SAN LEANDRO UNIFIED SCHOOL DISTRICT
Facilities and Construction - Bond Department

To: Facilities and Technology Committee
Today's Date: 08/26/2020
From: Bond Department
F&T Meeting Date: 09/02/2020
Project Description: Washington Modular Classrooms

Change Order

Project: **Washington Modular Classrooms**
250 Dutton Ave.
San Leandro, CA 94577

MECHANICAL FLOOR PLANS BUILDINGS F, G1, G2 & G3

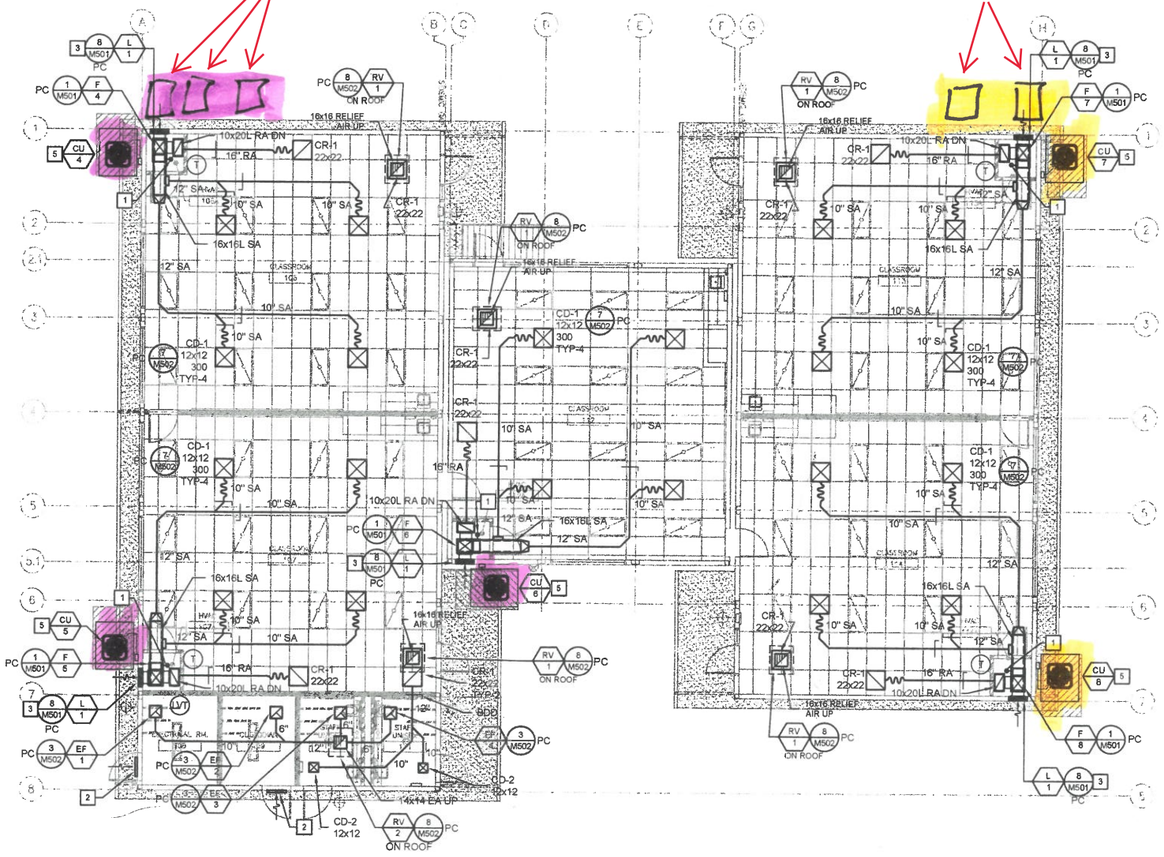
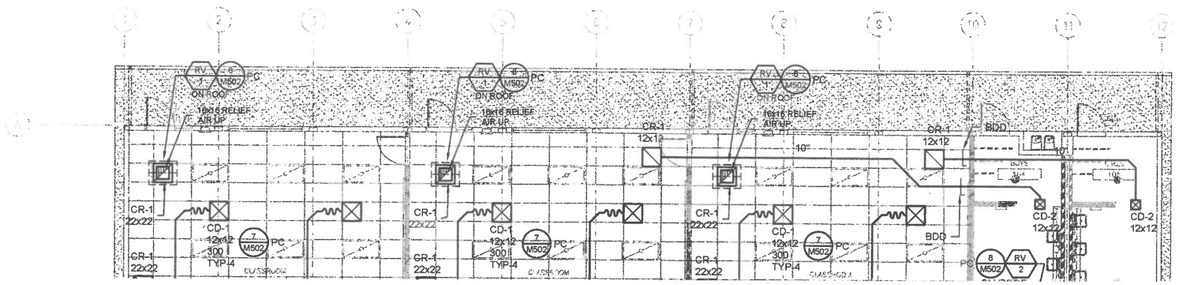
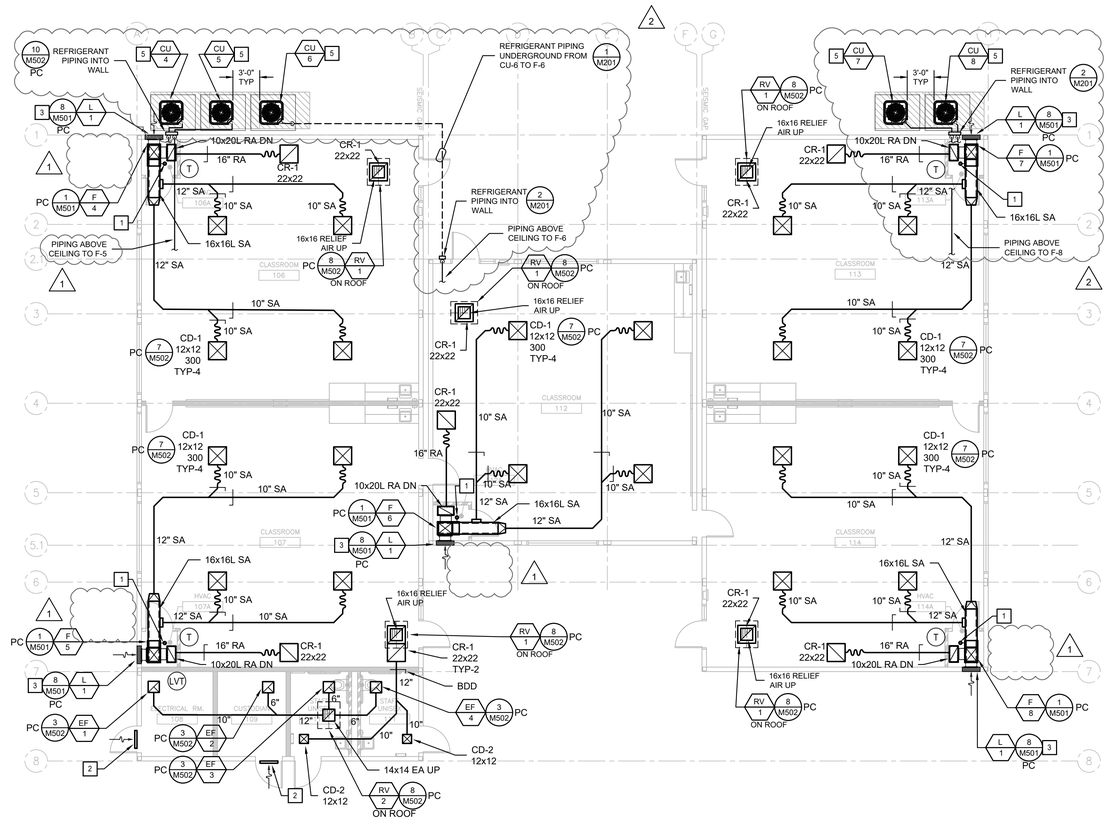
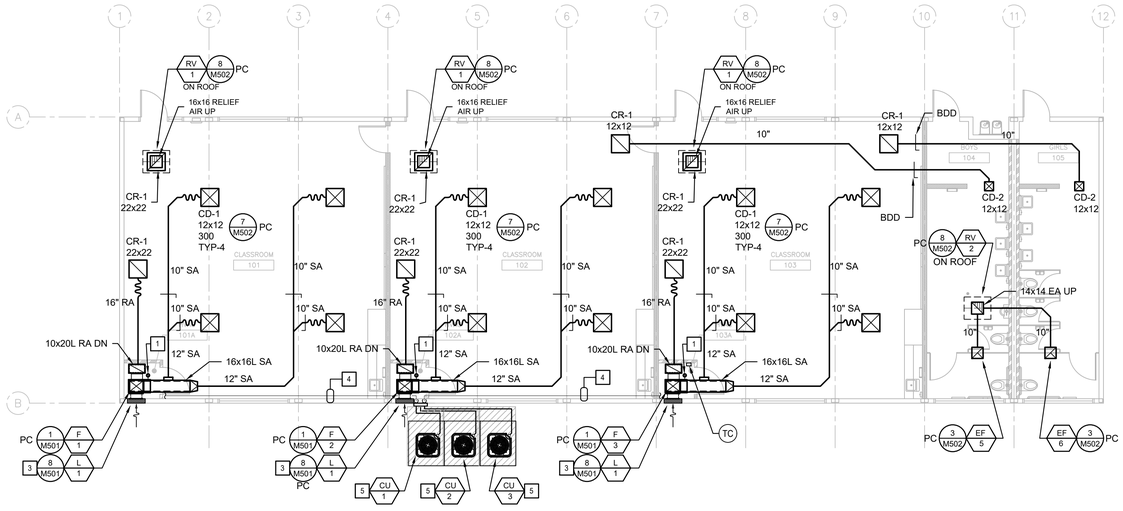
Subject: Bldg. G CU Locations

Per RFI 010, we moved the locations of the CUs at Bldg G of the Washington ES project to get the CUs out of the ADA path of travel.The District would like to revise the new locations to minimize the amount of underground line set runs and move them to the locations identified in the attached drawing.

Please review and confirm this is acceptable. If acceptable, please provide an updated drawing showing the new CU location.

Proposed New locations for G2 & G3 CU's

Proposed New locations for G1 CU's

The proposed revised condensing unit locations are acceptable. Please see attached revised sheet M201.

ISSUE:	DESCRIPTION:	DATE:
1	RELOCATED CONDENSING UNITS	06.29.2020
2	RELOCATED CONDENSING UNITS	08.21.2020

DRAWING NUMBER: **ES-101**

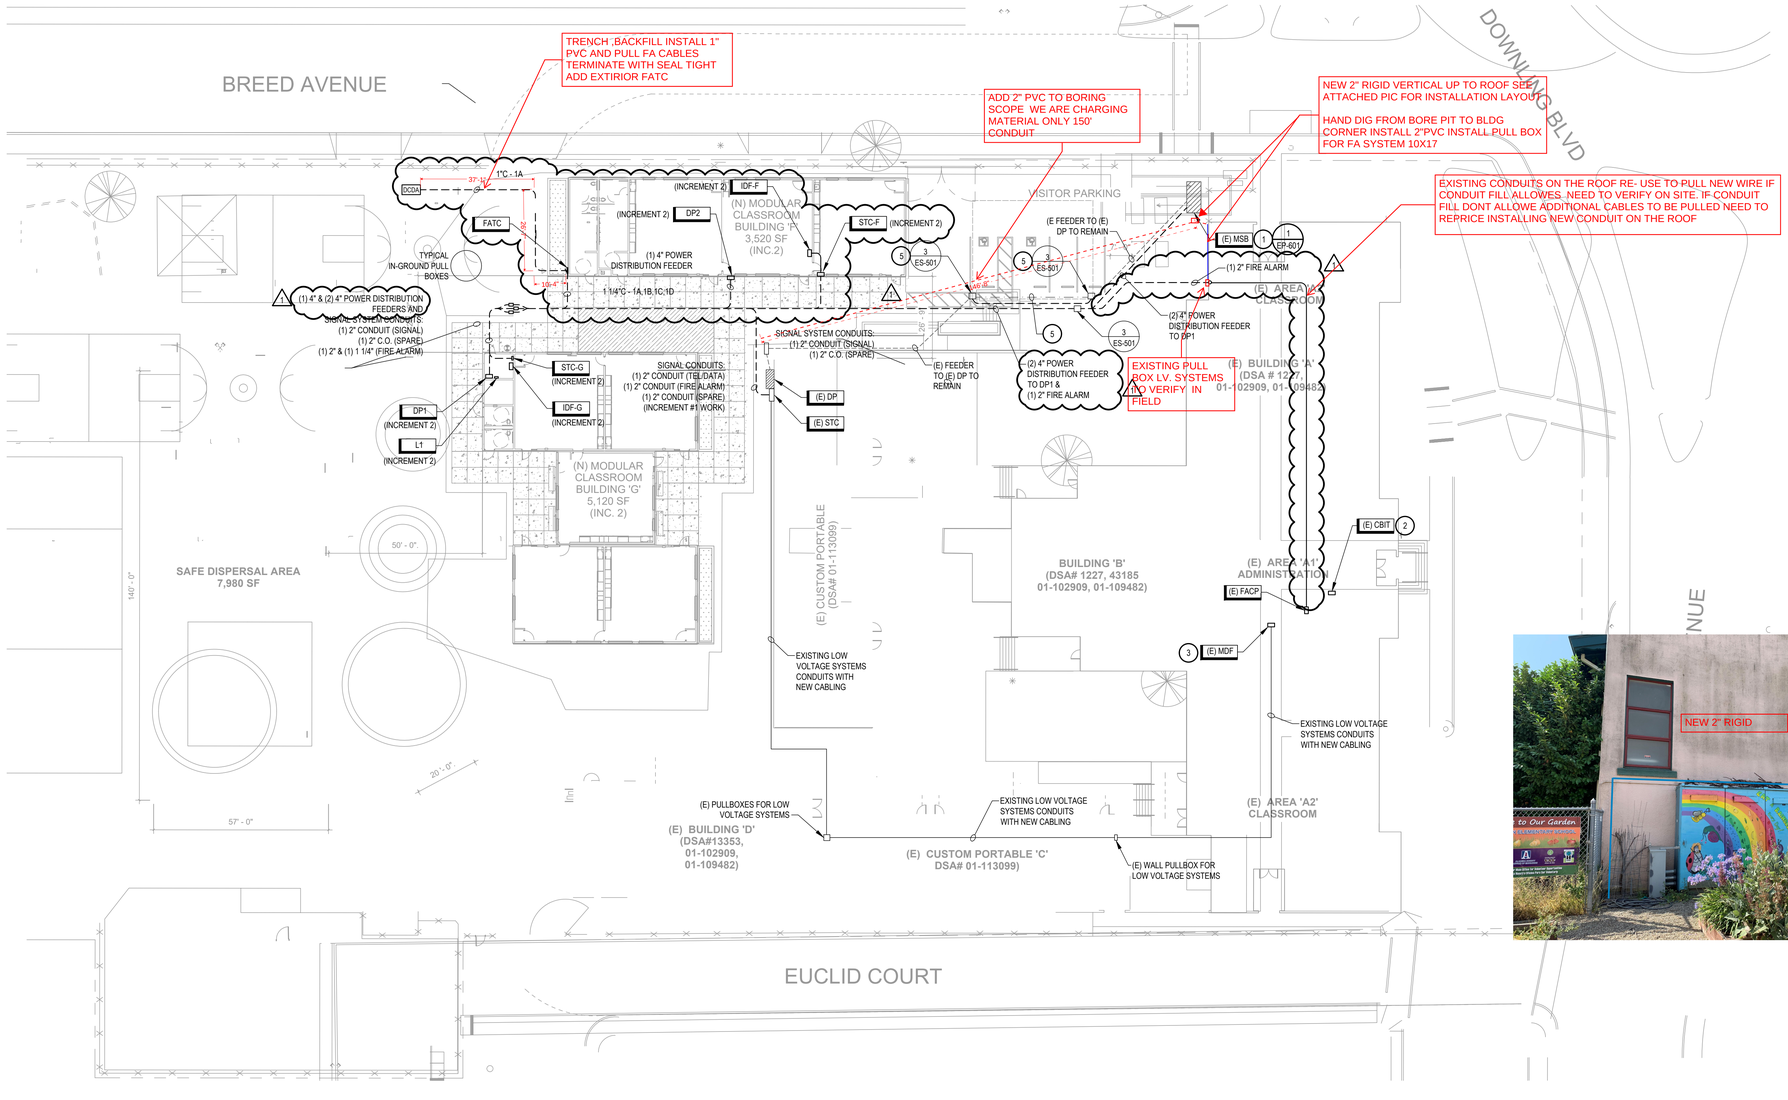
Costs associated with additional underground fire alarm work shown in the revised ES-101 sheet that was provided in RFI 011. Costs include additional underground conduit for fire alarm monitoring of the DDVA, new FATC at Bldg F, additional underground 2" conduit for fire alarm, new 2" rigid conduit up to the roof of the existing Bldg A, new pull box for fire alarm system, etc.

C/O Number:	3	**Comments**
Sequence:	0	ADDED/CHANGED UNDERGROUND SCOPE PER REVISED ES-101
Owner C/O No:	JLC RFI#11

Delta #1 Revision
